SERVICE BULLETIN

SB97-6B**FAA APPROVED**Supersedes M87-11 REV. 2,
SB97-6, 6A**SUBJECT:** MANDATORY REPLACEMENT PARTS**PURPOSE:** TO IDENTIFY ITEMS TO BE REPLACED DURING MAINTENANCE,
PREVENTATIVE MAINTENANCE AND OVERHAUL**COMPLIANCE:** DURING MAINTENANCE, PREVENTATIVE MAINTENANCE AND
OVERHAUL**MODELS AFFECTED:** ALL MODELS

ISSUED	REVISED	 P.O. Box 90 Mobile, AL 251-436-8299	PAGE NO	DOC NO	REVISION
2005/08/09	2017/07/18		1 of 18	CSB05-8C

ISSUED	REVISED	 P.O. Box 90 Mobile, AL 251-436-8299	PAGE NO	DOC NO	REVISION
2005/08/09	2018/08/22		1 of 18	CSB05-8D

Figure 1. Un-Modified Permold Crankcase

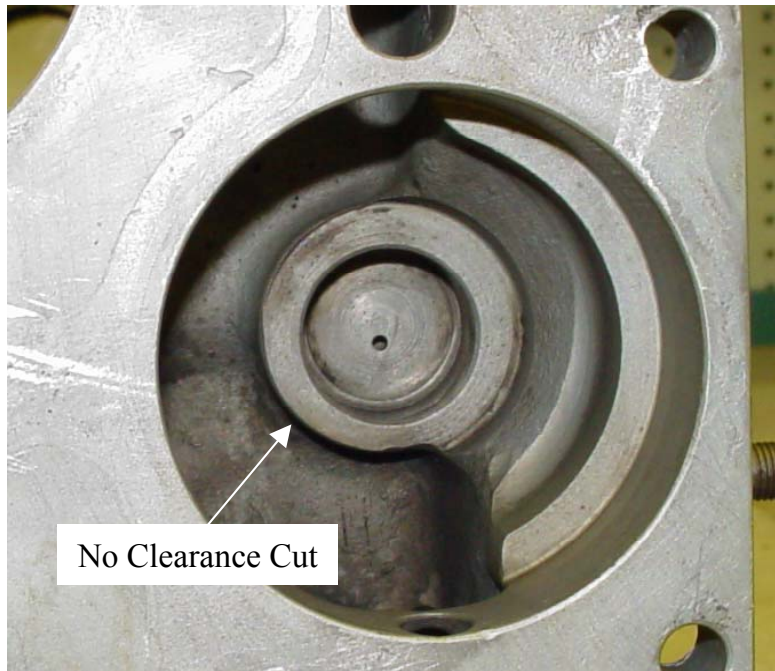
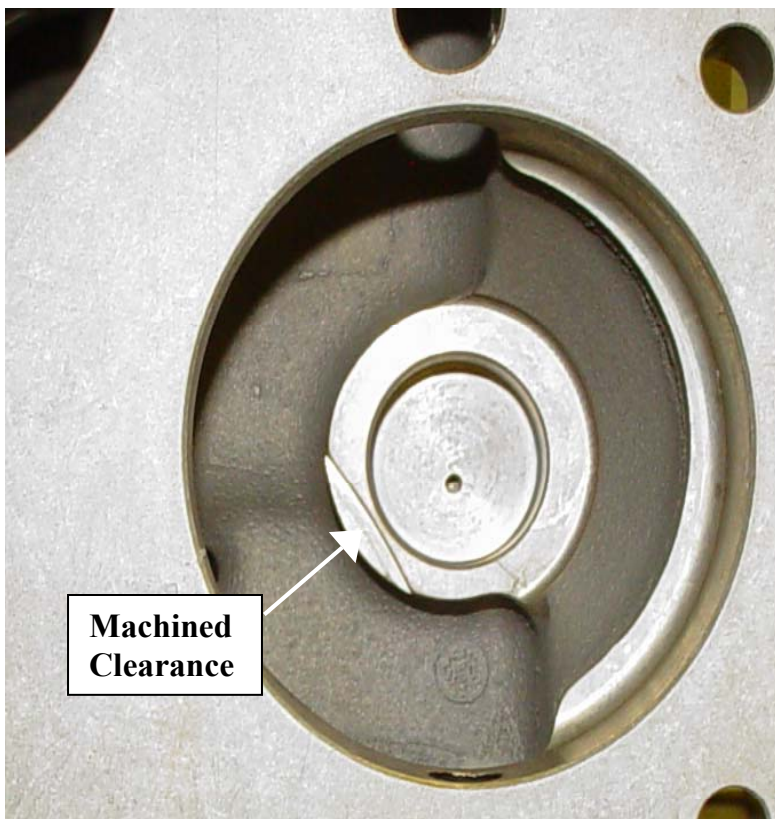
The P/N 656818 camshaft gear is nominally 0.060" wider than the P/N 656031 camshaft gear. On engine models utilizing the Sandcast style of crankcase, the P/N 656818 camshaft gear may be installed as a direct replacement for the P/N 656031 camshaft gear. On engine models utilizing the Permold style of crankcase, modification of the starter adapter bearing boss is required to provide clearance for the wider camshaft gear.

The Permold style of crankcase must be modified to allow use of the new, thicker camshaft gear. A clearance cut is made in the starter drive bearing boss in accordance with the dimensions shown in Figure 3. TCM recommends that a properly certified repair station machine the required clearance.

CAUTION... Installation of the new P/N 656818 gear in an unmodified permold style crankcase will result in damage to the gear and/or the crankcase

Figure 4. Inspect For Clearance Between The Camshaft Gear And The End Of The Oil Gallery Plug (Where Indicated).

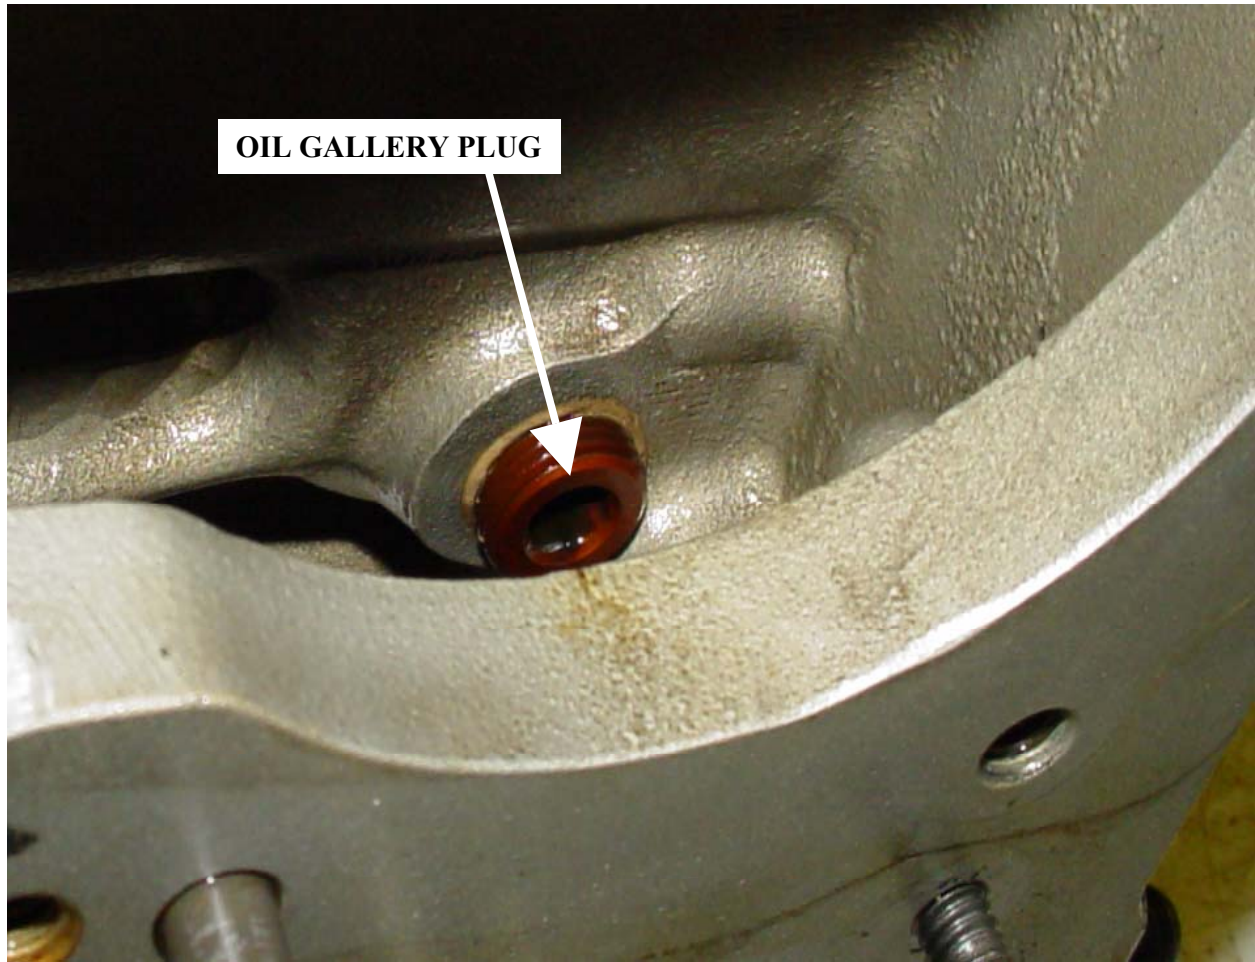
NOTE . . . On Sandcast crankcase installations clearance must be verified between the new P/N 656818 camshaft gear and the oil gallery plug located directly below the starter adapter boss. (Reference figure 4.)

FIGURE 1
UN-MODIFIED PERMOLD CRANKCASE

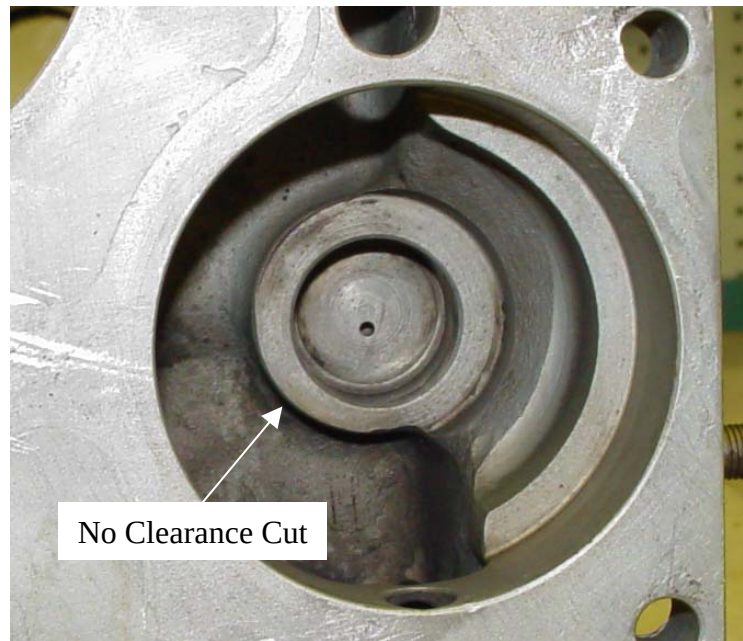
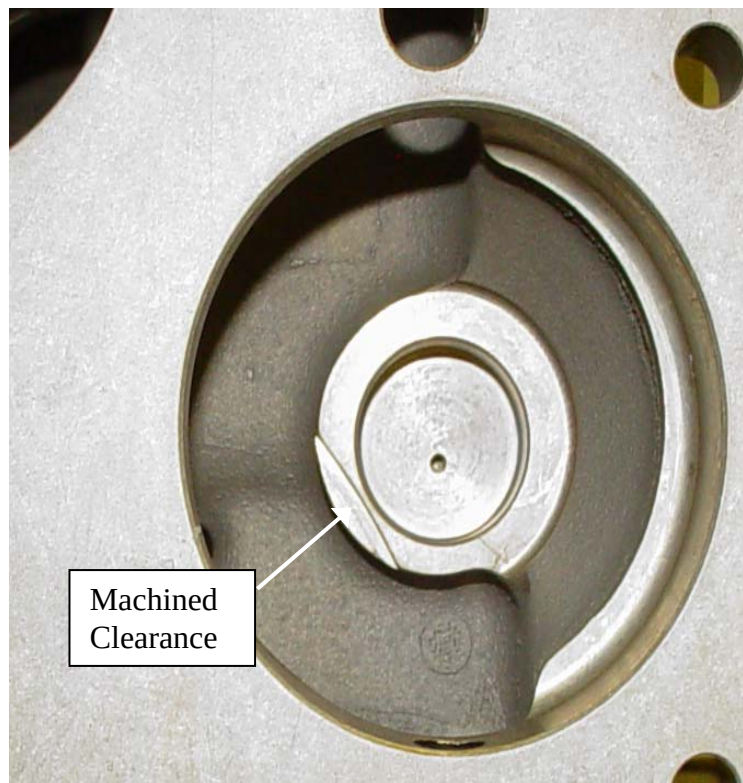
The P/N 656818 camshaft gear is nominally 0.060" wider than the P/N 656031 camshaft gear. On engine models utilizing the Sandcast style crankcase, the P/N 656818 camshaft gear may be installed as a direct replacement for the P/N 656031 camshaft gear. On engine models utilizing the Permold style crankcase, modification of the starter adapter shaftgear bearing boss is required to provide clearance for the wider camshaft gear.

The Permold style of crankcase must be modified to allow use of the new, thicker camshaft gear. A clearance cut is made in the starter drive bearing boss in accordance with the dimensions shown in Figure 3. TCM recommends that a properly certified repair station machine the required clearance.

CAUTION... *Installation of the new P/N 656818 gear in an unmodified permold style crankcase will result in damage to the gear and/or the crankcase*

FIGURE 4
INSTALL CAMSHAFT IN CRANKCASE HALF
INSPECT FOR MINIMUM OF .030 CLEARANCE BETWEEN THE CAMSHAFT
GEAR AND THE END OF THE OIL GALLERY PLUG (WHERE INDICATED).

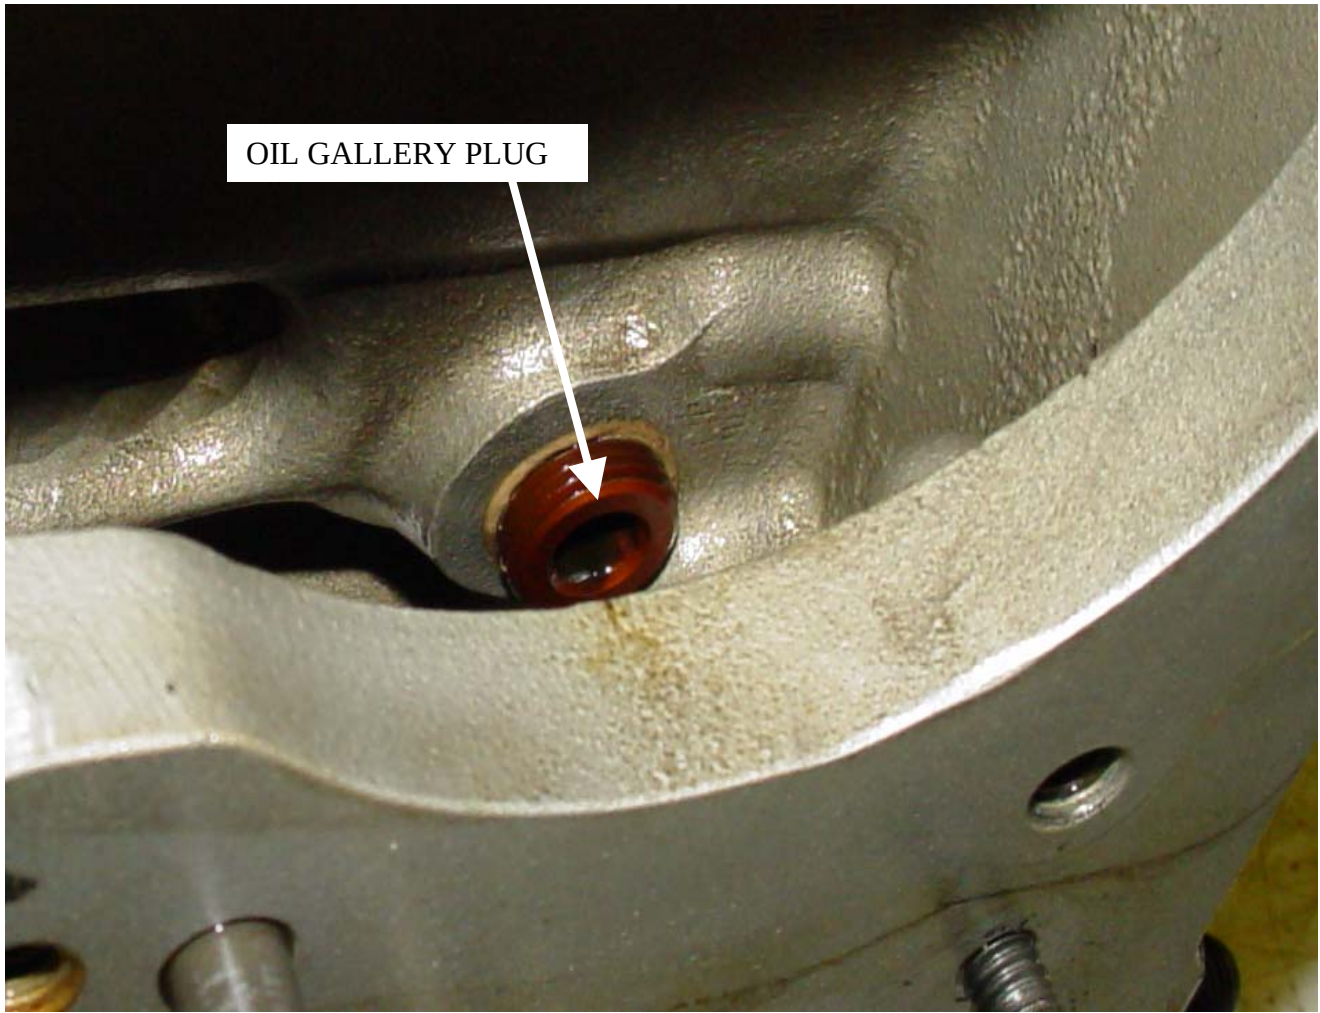
NOTE... On Sandcast crankcase installations clearance must be verified between the new P/N 656818 camshaft gear and the oil gallery plug located directly below the starter adapter boss.
(Reference figure 4.)

Figure 1. 1-3-5 Permold Crankcase Half, Clearance Cut Modification

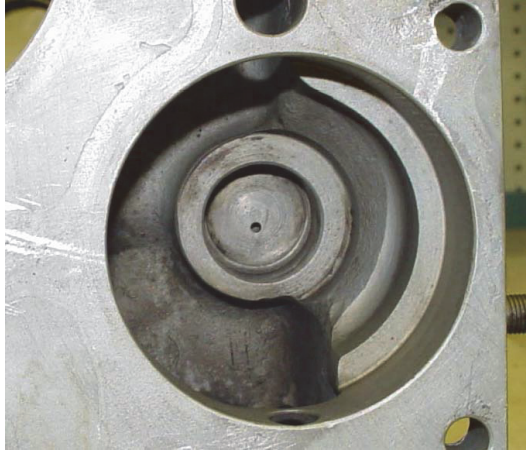
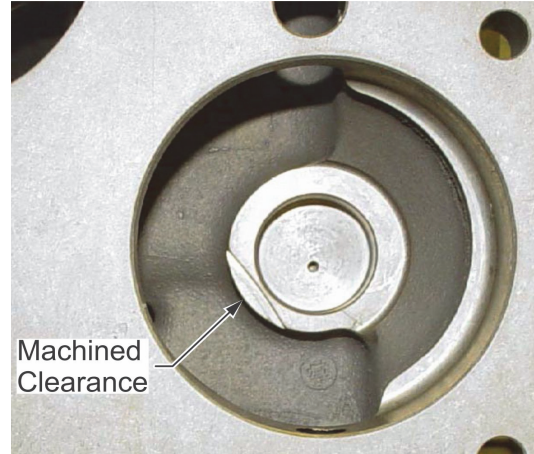
Camshaft gear, P/N 656818, is 0.060” thicker than the P/Ns 631845, 655430, 655516, or 656031 camshaft gears. The starter adapter bearing boss in Permold crankcases must be machined with a radius cut to provide clearance for the camshaft gear, P/N 656818. For engines with a Sandcast crankcase, the assembler must inspect the clearance between the new camshaft gear and the oil gallery plug installed in the rear of the crankcase below the starter adapter.

CAUTION: Installing the new camshaft gear, (P/N 656818) in an unmodified Permold crankcase will result in damage to the gear and crankcase.

Figure 3. Radius Clearance Cut Distance from Camshaft Centerline

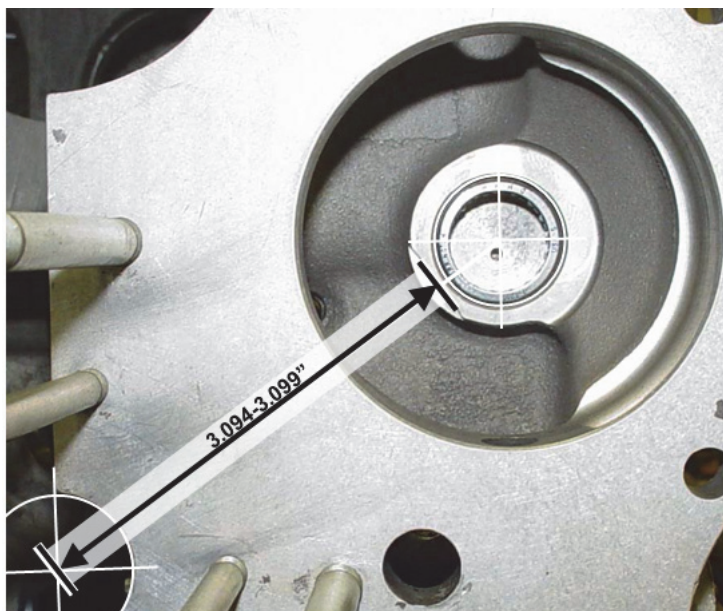
- a) Measure 3.094"- 3.099" from the camshaft bore centerline to the center of the starter drive bearing boss (Figure 3).
 - b) Cut a 0.005 - 0.015" radius in the outside edge of the starter drive bearing boss at a depth of 2.100 - 2.110" (Figure 4) from the accessory face (see step V. 3. a. 1).
- 2) Proceed with engine overhaul according to the instructions in the primary ICA.
- b. Sandcast Crankcase Inspection:
- 1) Install the camshaft, with camshaft gear 656818, in the crankcase gear according to the instructions in the primary ICA.

Figure 5. Lower Rear Oil Gallery (Control) Plug - Sandcast 1-3-5 Crankcase Half

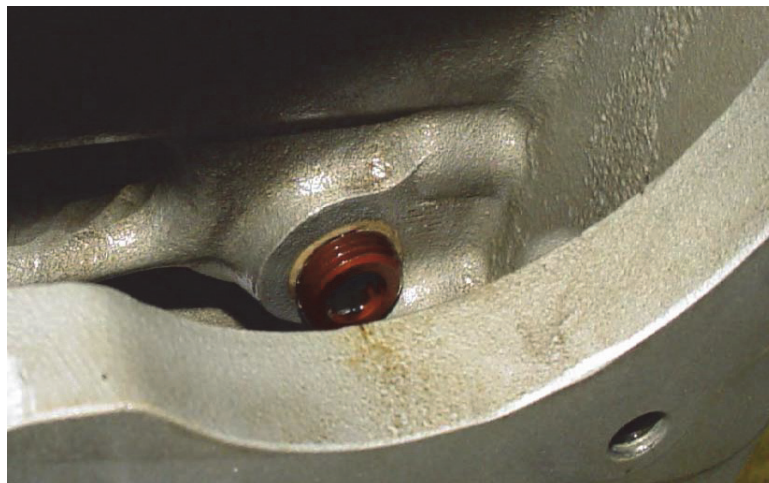
- 2) Measure the clearance between the oil gallery plug and the camshaft gear. If clearance is less than 0.030", remove the plug, clean the sealant residue from the crankcase and plug threads, and reinstall the plug to the maximum allowable torque specified in M-0, "Standard Practice Maintenance Manual," Appendix B and verify required minimum clearance.

Figure 3. 1-3-5 Permold Crankcase Half, Boss Clearance Cut Repair

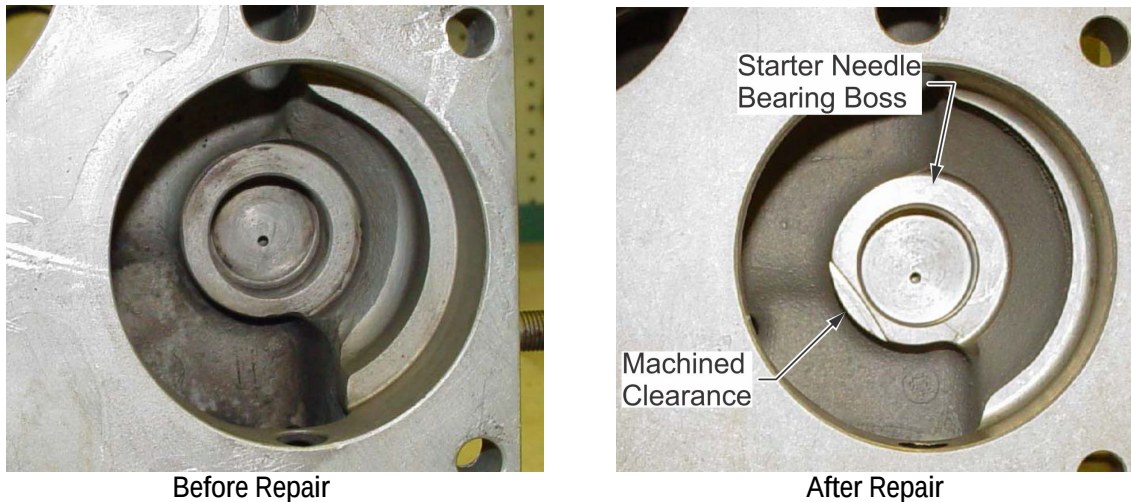
1. Inspect the needle bearing boss in the center of the starter adapter mounting pad. If a clearance cut (Figure 3) is present or if a clearance of 0.030" (or greater with the camshaft and gear installed) is provided under all conditions, the crankcase meets the clearance requirement.

Figure 4. Radius Clearance Cut, Distance from Camshaft Bore Centerline, Permold Crankcase

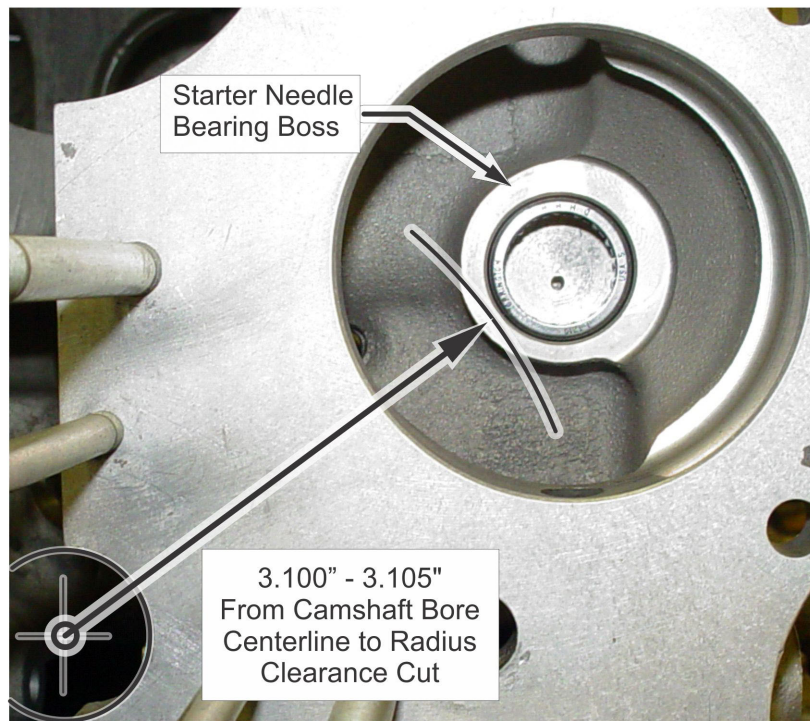
1. Measure and mark 3.100"- 3.105" from the camshaft bore centerline radius to the starter needle bearing boss (see Figure 4).
2. Cut a radius clearance cut in the outside edge of the starter drive needle bearing boss at a depth of 2.100 - 2.110" (see Figure 5) from the crankcase accessory mounting face.

Figure 20. Lower Rear Oil Gallery (Control) Plug, Sandcast 1-3-5 Crankcase Half

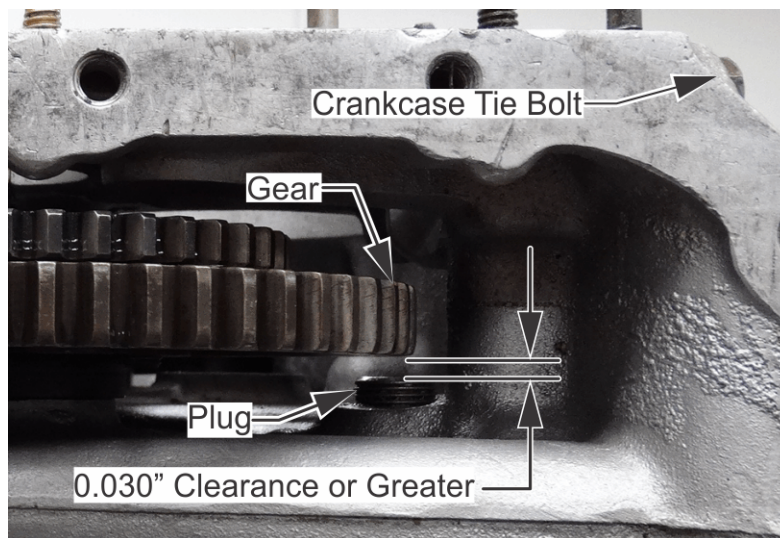
CAUTION: Camshaft gear (P/N 656818) is 0.060" wider at the circumference than the replaced camshaft gears (P/Ns 631845, 655430, 655516, or 656031). For engines with a Sandcast crankcase, the assembler must inspect and sustain a minimum clearance (0.030" or greater) between the camshaft gear (P/N 656818) and the oil gallery plug at the rear crankcase below the starter adapter (see step k. and Figure 20)).

- k. Measure the clearance between the oil gallery plug and the camshaft gear using a feeler gauge (see Figure 20). Ensure the minimum clearance is 0.030" or greater. If the clearance is less than 0.030":

- 1) Remove the safety wire and the rear crankcase tie bolt (P/N 627433) according to the instructions in the primary ICA (if it is blocking access to the oil gallery plug).

- 2) Remove the half-height alignment screw and remove the camshaft gear.
 - 3) Remove the oil gallery plug, clean the sealant residue from the crankcase and plug threads.

- 4) Install the oil gallery plug (according to the instructions in the primary ICA) to the maximum allowable torque specified in M-0, "Standard Practice Maintenance Manual, Appendix B" and verify required minimum clearance (0.030" or greater) is met.

Figure 3. 1-3-5 Permold Crankcase Half, Boss Clearance Cut Repair

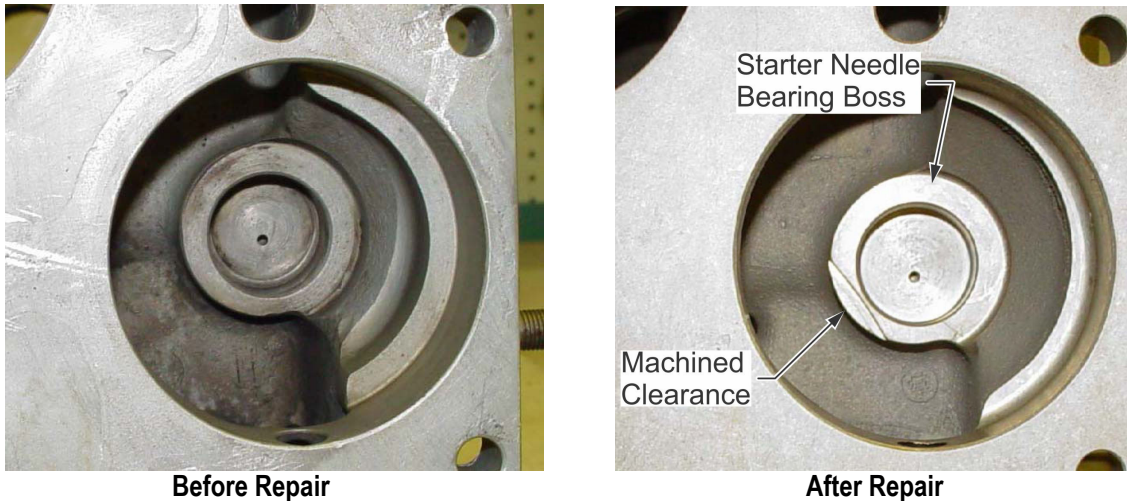
1. Inspect the needle bearing boss in the center of the starter adapter mounting pad. If a clearance cut (Figure 3) is present or if a clearance of 0.030" (or greater with the camshaft and gear installed) is provided under all conditions, the crankcase meets the clearance requirement.

Figure 4. Radius Clearance Cut, Distance from Camshaft Bore Centerline, Permold Crankcase

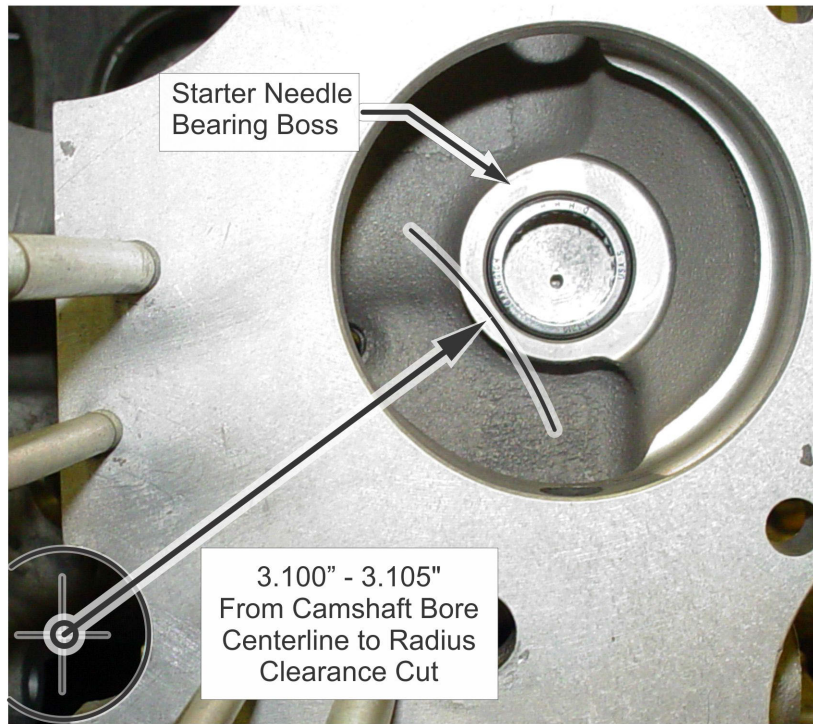
1. Measure and mark 3.100"- 3.105" from the camshaft bore centerline radius to the starter needle bearing boss (see Figure 4).
2. Cut a radius clearance cut in the outside edge of the starter drive needle bearing boss at a depth of 2.100 - 2.110" (see Figure 5) from the crankcase accessory mounting face.

Figure 20. Lower Rear Oil Gallery (Control) Plug, Sandcast 1-3-5 Crankcase Half

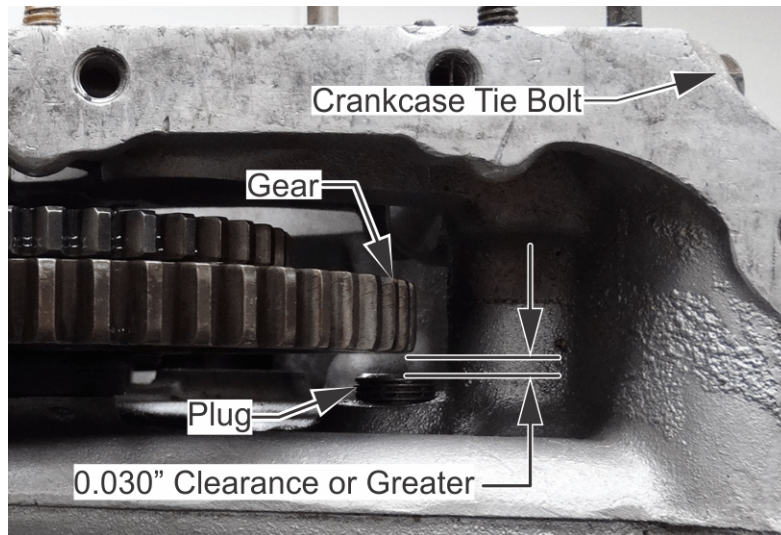
CAUTION: Camshaft gear (P/N 656818) is 0.060" wider at the circumference than the replaced camshaft gears (P/Ns 631845, 655430, 655516, or 656031). For engines with a Sandcast crankcase, the assembler must inspect and sustain a minimum clearance (0.030" or greater) between the camshaft gear (P/N 656818) and the oil gallery plug at the rear crankcase below the starter adapter (see step k. and Figure 20)).

- k. Measure the clearance between the oil gallery plug and the camshaft gear using a feeler gauge (see Figure 20). Ensure the minimum clearance is 0.030" or greater. If the clearance is less than 0.030":

- 1) Remove the safety wire and the rear crankcase tie bolt (P/N 627433) according to the instructions in the primary ICA (if it is blocking access to the oil gallery plug).

- 2) Remove the half-height alignment screw and remove the camshaft gear.
 - 3) Remove the oil gallery plug, clean the sealant residue from the crankcase and plug threads.
